CALIFORNIA COASTAL COMMISSION

NE-0001-22 (USACE)

May 12, 2022

**SUBJECT: Modification to Coastal Consistency Determination for the Port
San Luis Breakwater Repair (CD-0002-21) Briefing Memo**

[Exhibit 2 – Proposed Placement Area Site Map](#)

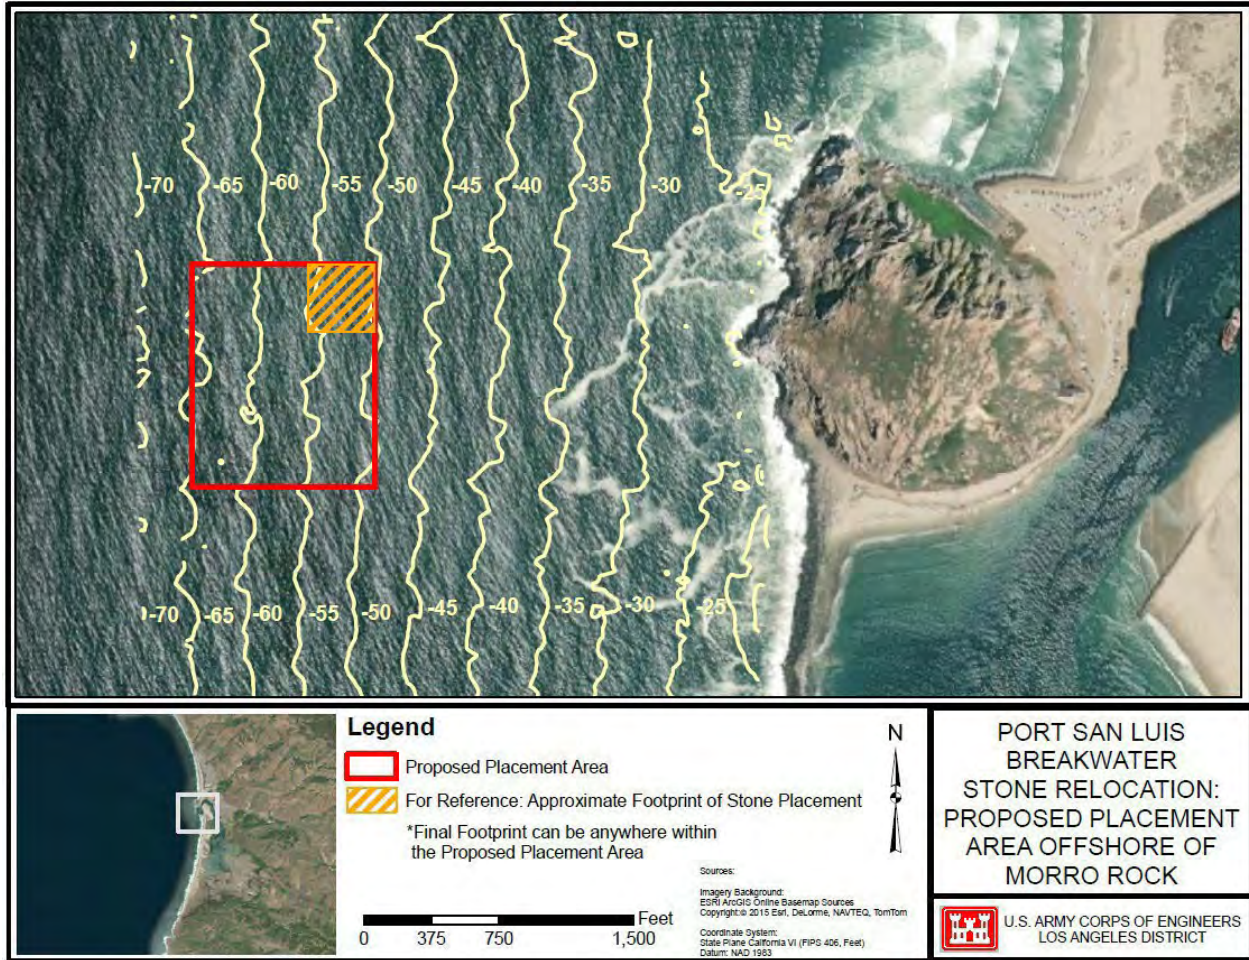
Constructed at the turn of the last century, most of the Port San Luis Breakwater was built with stone quarried from Morro Rock, a recognized sacred site for both the Chumash and Salinan Tribes. As part of the tribal consultation process for the Port San Luis Breakwater repair, the Corps was informed by the yak tityu tityu yak tiñini - Northern Chumash Tribe and the Northern Chumash Tribal Council that the rock maintains its sacredness despite its removal from Morro Rock. Based on input from the consulting tribes, further adverse effects to the stone could only be avoided by either retaining the unity of the translocated stone by keeping it in the breakwater or by relocating the stone back to Morro Rock where it would be placed in a unified manner in the waters adjacent to Morro Rock. At one point, the Corps was considering placing displaced stone that could not be placed back in the breakwater, in the nearshore waters closer to PSL. However, having reviewed the environmental and safety constraints and coordinating with the Chumash Tribes, it was determined to be environmentally and culturally preferable to relocate the displaced stone back to Morro Rock where it would be placed in waters between -50 and -65 feet MLLW directly west of Morro Rock.

Port San Luis Breakwater Stone Relocation Configuration

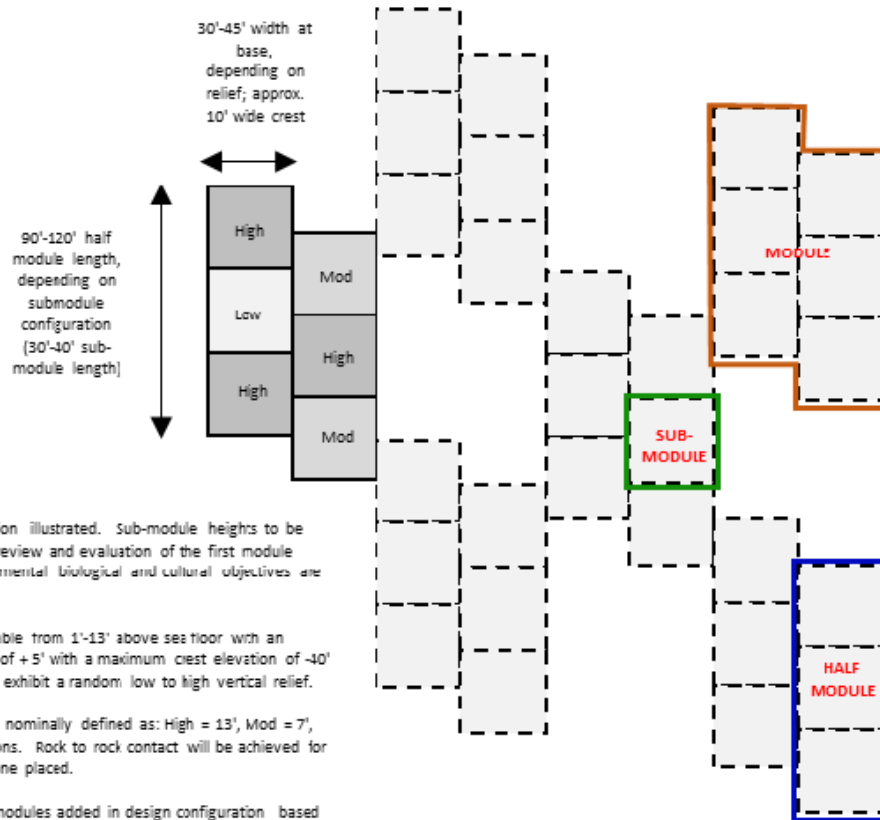
- 1) Typical Module Configuration illustrated. Sub-module heights to be directed by Corps following review and evaluation of the first module placement to ensure environmental biological and cultural objectives are being achieved.
- 2) Sub-module height is variable from 1'-13' above sea floor with an allowable upward tolerance of +5' with a maximum crest elevation of -40' MLLW so that the structures exhibit a random low to high vertical relief.
- 3) Module target heights are nominally defined as: High = 13', Mod = 7', Low = 1' feet at peak elevations. Rock to rock contact will be achieved for a minimum of 85% of the stone placed.
- 4) Contiguous connected modules added in design configuration based on the volume of rock relocated with additional modules being added in a progression following the numbered units.
